Technical Note TN-800

Tait Orca 5010, 5015, 5020  
Firmware Upgrade to 2.11 &  
TOP-CPA Upgrade to 3.8.1

19 September 2003

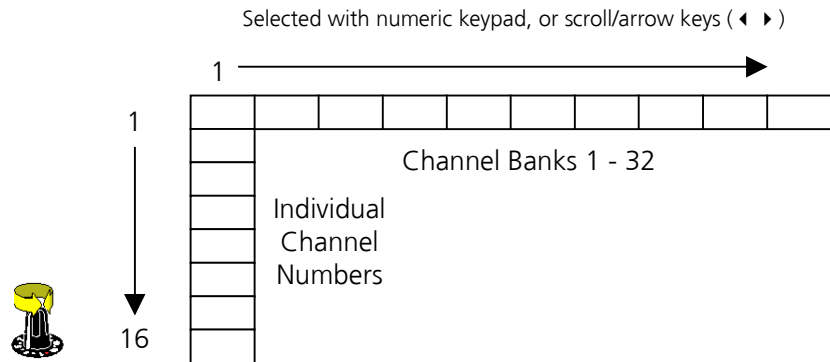
- CTCSS and DCS signalling now allowed on the same channel. (Raised as TIMS 16022).

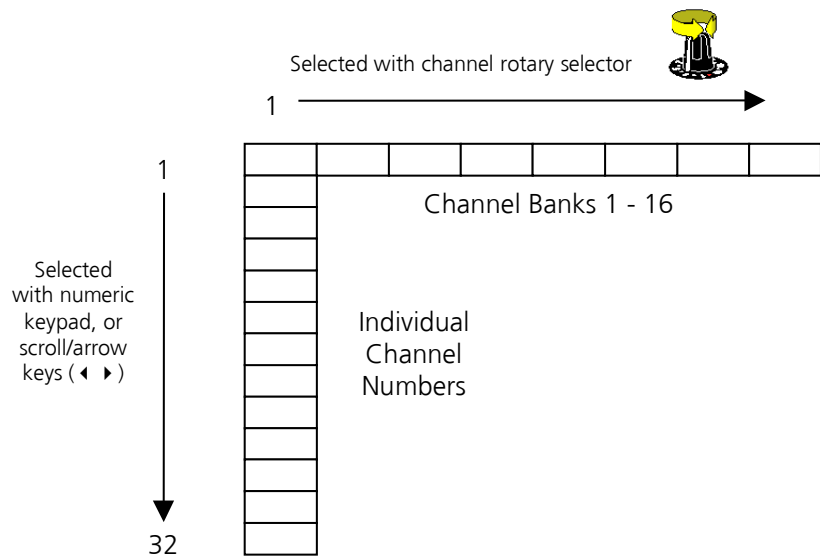
- Channel Banks feature added to Orca 5020 (Raised as TIMS 18381).

This feature provides a new method of channel switching. It divides the total available channels into banks (blocks) of channels. There are then two options of navigating the channels. These new options are available on the Channel Selection page. The options are in the 16-way Selector field.

➤ Banking – Channel Selection

When selected, the channel rotary selector of the radio will correspond to the channel to be selected

from within the currently active channel bank (block). The numeric keypad will handle changing of channel banks. Also the scroll/arrow keys (◀ ▶) scroll from channel bank to channel bank, a press of the Enter (✓) key confirms selection of a specific channel bank.

➤ Banking – Bank Selection

When selected, the channel rotary selector of the radio will correspond to the channel bank (block) to be selected.

The numeric keypad will handle the changing of channels. The scroll/arrow keys (◀ ▶) scroll from channel to channel within the active channel bank.
